V2500-A1/A5 SERIES PROPULSION SYSTEMS SERVICE BULLETIN

This document transmits the Initial Issue of Service Bulletin V2500-ENG-79-0098.

ENGINE – EXHAUST GAS TEMPERATURE (EGT) HARNESS CLIPPING MODIFICATION TO PREVENT
CHAFING ON FUEL MANIFOLD TUBE

V2500-ENG-79-0098

Locations of Clip Positions CP5211 and CP5529
Figure 1 Sheet 1

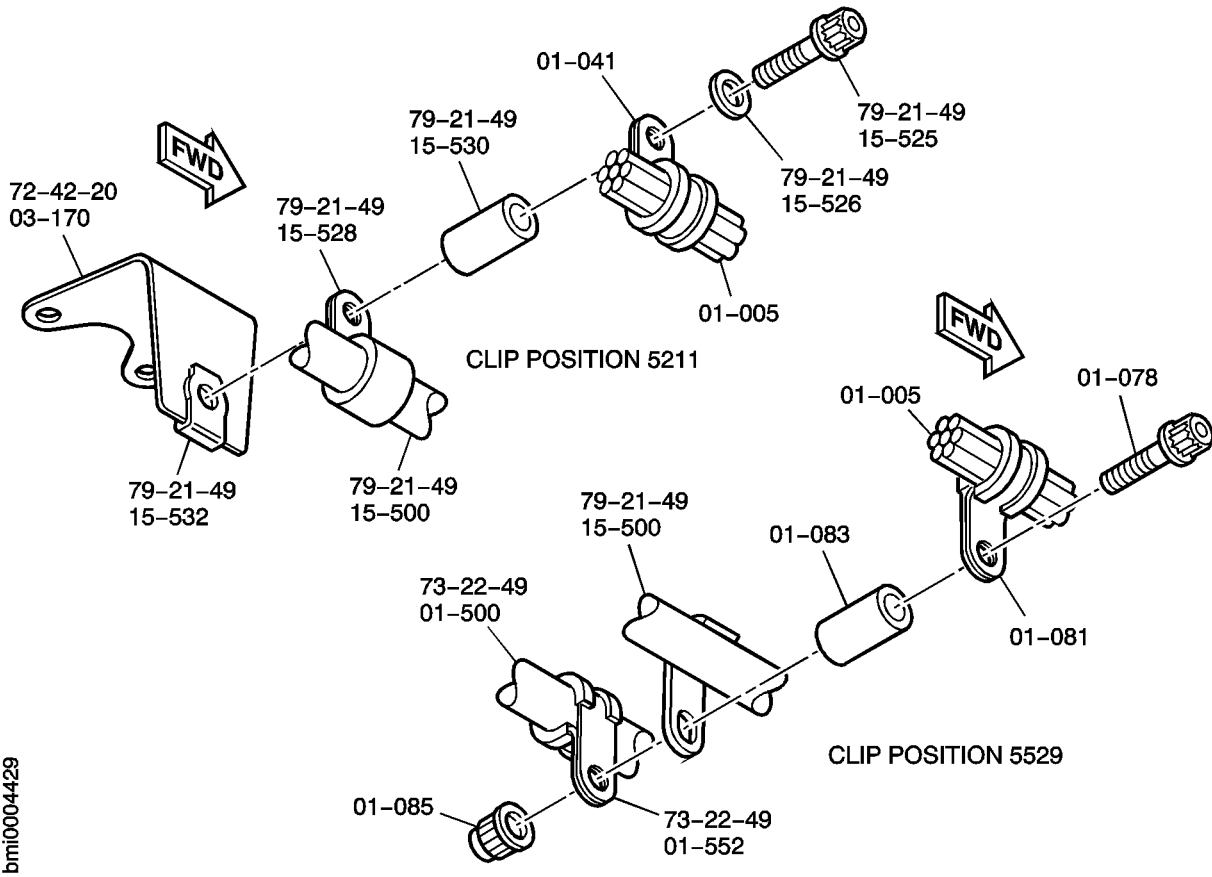
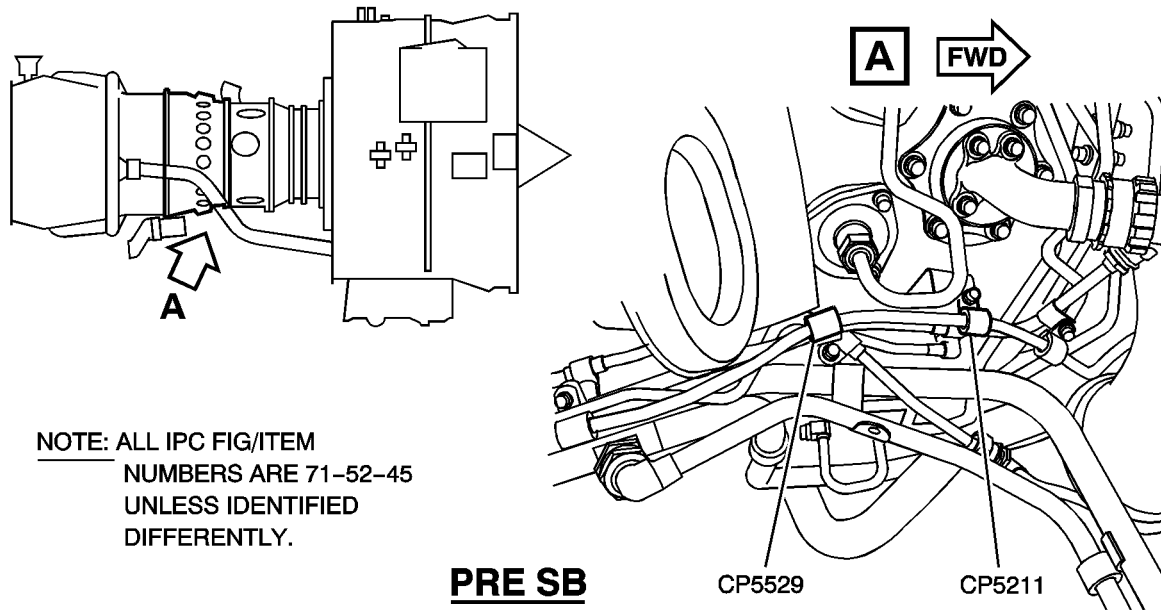
This Service Bulletin modifies the clip positions CP5211 and CP5529 to improve the route of the Exhaust Gas Temperature (EGT) harness.

- (1) On clip position CP5211, the length of the spacer and the length of the bolt is reduced.
- (2) On clip position CP5529, the clip attached to the EGT harness is rotated through 180 degrees around the axis of the bolt. There are no hardware changes to this clip position.

- (3) At the clip position CP5211:

- (a) Remove the old bolt (79-21-49, 15-525), P/N 4W0119, the washer (79-21-49, 15-526) and the old spacer (79-21-49, 15-530), P/N UP10482 or 5W1033 that attach the clip (71-52-45, 01-041) and the clip (79-21-49, 15-528) to the bracket (72-42-20, 03-170).
 - (b) Install the new bolt (79-21-49, 15-525), P/N 4W0116, the washer (79-21-49, 15-526) and the new spacer (79-21-49, 15-530), P/N UP10481 that attach the clip (71-52-45, 01-041) and the clip (79-21-49, 15-528) to the bracket (72-42-20, 03-170).

- (4) At the clip position CP5529:

- (a) Remove the nut (71-52-45, 01-085), the bolt (71-52-45, 01-078), and the spacer (71-52-45, 01-083) that attach the clip (71-52-45, 01-081) and the clip (73-22-49, 01-552) to the tube (79-21-49, 15-500).
 - (b) Remove the clip (71-52-45, 01-081) from the EGT harness (71-52-45, 01-005).
 - (c) Turn the clip (71-52-45, 01-081) through 180 degrees in the same plane and install it on the EGT harness (71-52-45, 01-005).
 - (d) Install the bolt (71-52-45, 01-078), the spacer (71-52-45, 01-083) and the nut (71-52-45, 01-085) that attach the clip (71-52-45, 01-081) and the clip (73-22-49, 01-552) to the tube (79-21-49, 15-500).

- (5) Make a check that the EGT harness (71-52-45, 01-005) has the minimum clearance of 0.2 in. (5 mm) between the EGT harness and the fuel manifold tube and the other parts.
- (6) Torque the bolt (79-21-49, 15-525) (CP5211) and the nut (71-52-45, 01-085) (CP5529) to 36-45 lbf in. (4-5 Nm).
- (7) Make sure that the work area is clean and clear of tools, equipment and other unwanted materials.
